Flight Procedures Cover Page	Task Action: FLIGHT CHECK	Task Type: IAP	Estimated Chart Date: 03/19/2026	APWS Task ID: 89FB11D9E444E2192CFBE408DF3B02C	APWS Project ID: ADB5B885B35444BD98C66E27013D2BA6
Procedure: RNAV (RNP) Z RWY 34L AMDT 1		Enroute: NO	Specialist: Dugan, Joshua		Agreement Number:
Airport ID: KDEN			Airport City: DENVER	State: CO	
Facility ID:	Facility Type:	Flight Inspection Remark Type: New FC Slot			
<p>Procedure Comments:</p> <p>ACTIVE DATA USED FOR KDEN</p> <p>RAISE MISSED ALTITUDE</p> <p>CONTACT ROBERT HAMILTON AJV-A433 405-954-4608</p> <p>10/08/25: THIS IS AN UPDATED COPY OF THE FORM DEVELOPED ON 07/15/25.</p> <p>1. PROFILE LINE 3 REMOVED TUGGL AS FAF.</p> <p>2. PROFILE LINE 7 ADDED 34:1 IS CLEAR AND 20:1 IS CLEAR.</p> <p>3. ADDED CHART SPEED ICON IN PLANVIEW AT KALHR: MAX 210 KIAS.</p> <p>8260-1</p> <p>1. REMOVED WAIVER.</p> <p>APPROVAL LETTER</p> <p>1. ADDED APPROVAL LETTER FOR MANDATORY ALTITUDE AT MERKL.</p>

SUBJECT: APPROVAL: DENVER, CO KDEN RNAV (RNP) Z RWY 34L

ISSUE: MANDATORY ALTITUDE RESTRICTION: INTERMEDIATE SEGMENT KALHR TO MERKL

RNAV (RNP) Z RWY 34L

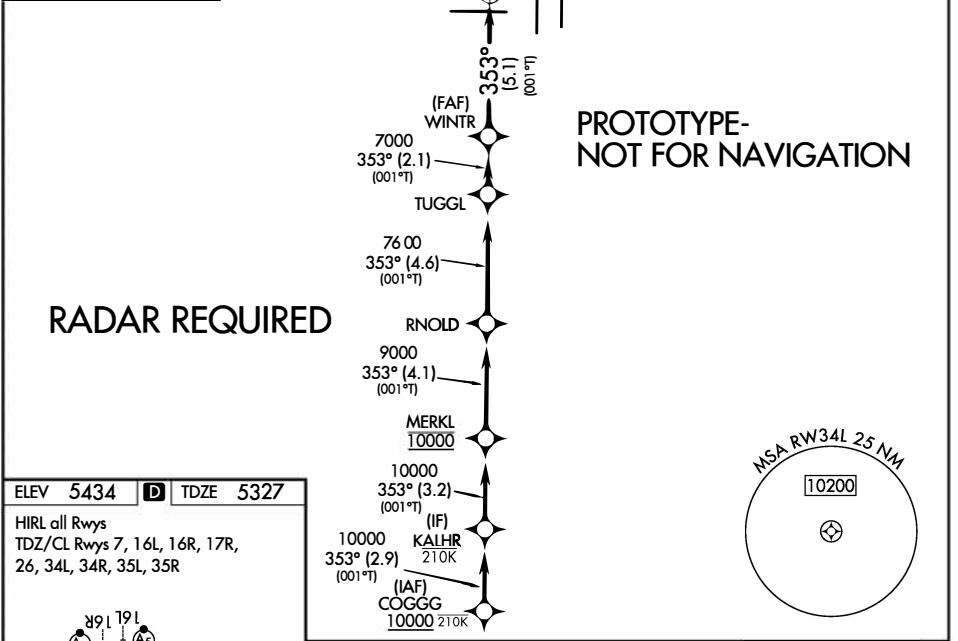
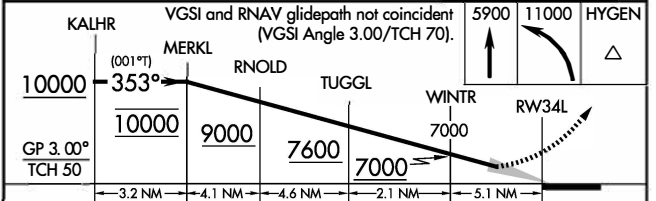
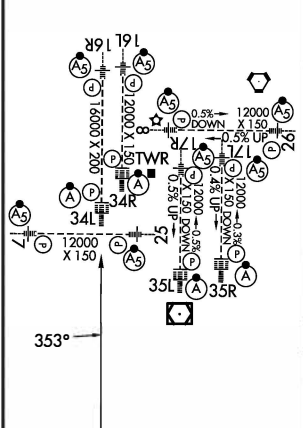
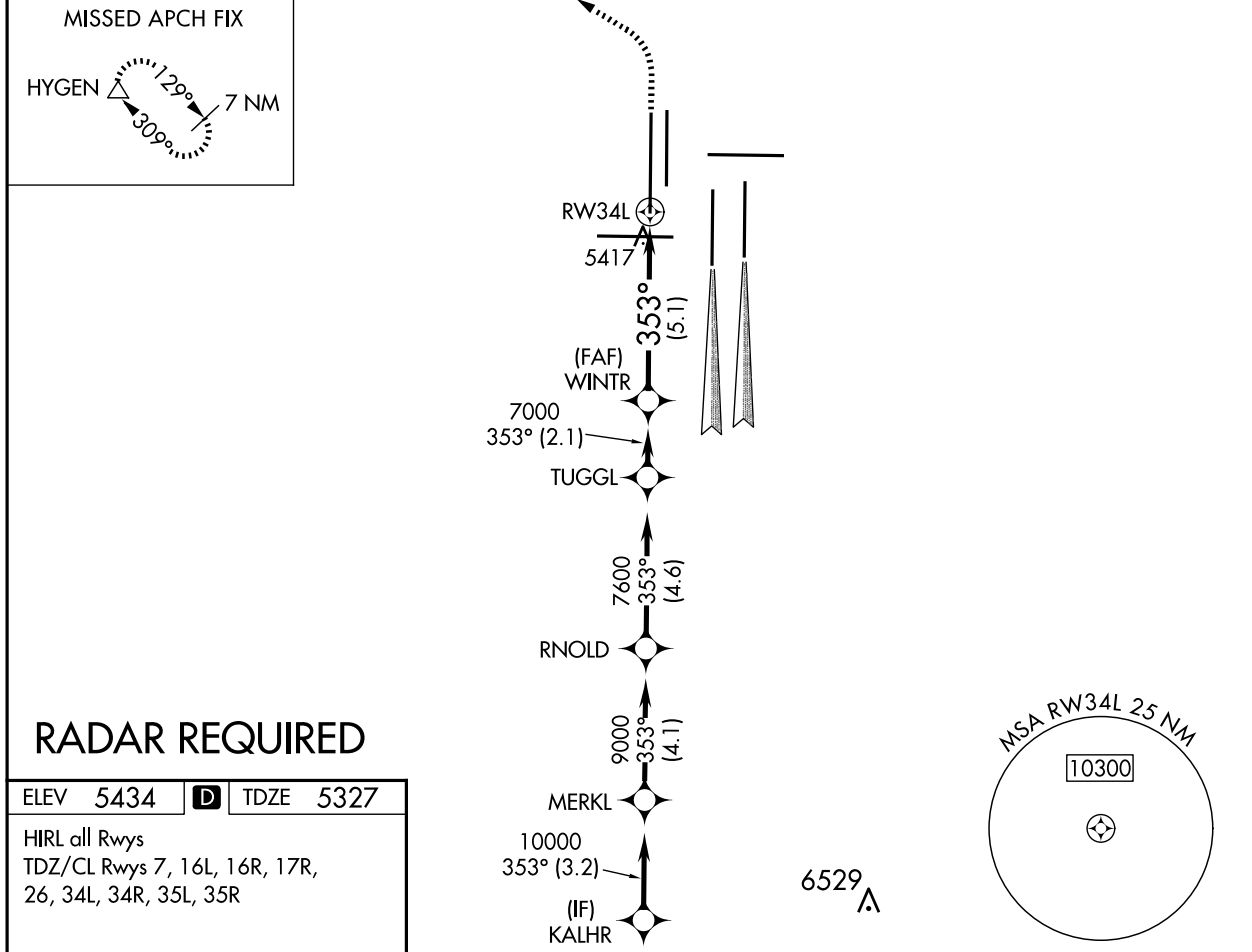
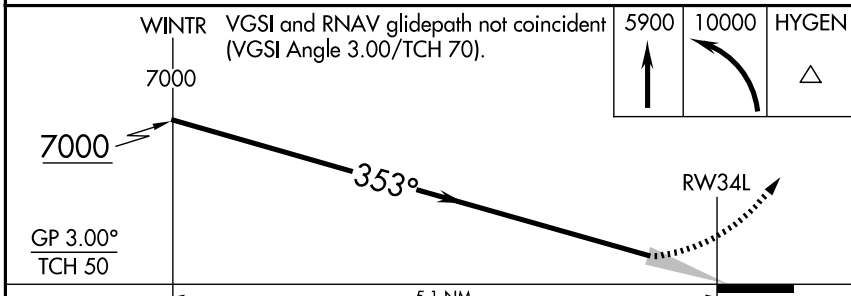
The intermediate segment for the RNAV (RNP) Z RWY 34L KALHR to MERKL has a mandatory altitude of 10000 MSL. ATC has requested mandatory altitude at MERKL to ensure aircraft separation during simultaneous operations.

Requesting approval to publish the mandatory altitude restriction at the intermediate fix MERKL to match the ILS procedure.

Per the 8260.19K 8-6-11n, maximum, mandatory or block altitudes in the intermediate, final and/or missed approach segment require Flight Standards approval.

This procedure has been flight checked and flown as satisfactory in both the current revision and previous amendments with the same mandatory altitude restriction with no issues noted by Flight Check, ATC operations or the flying public.
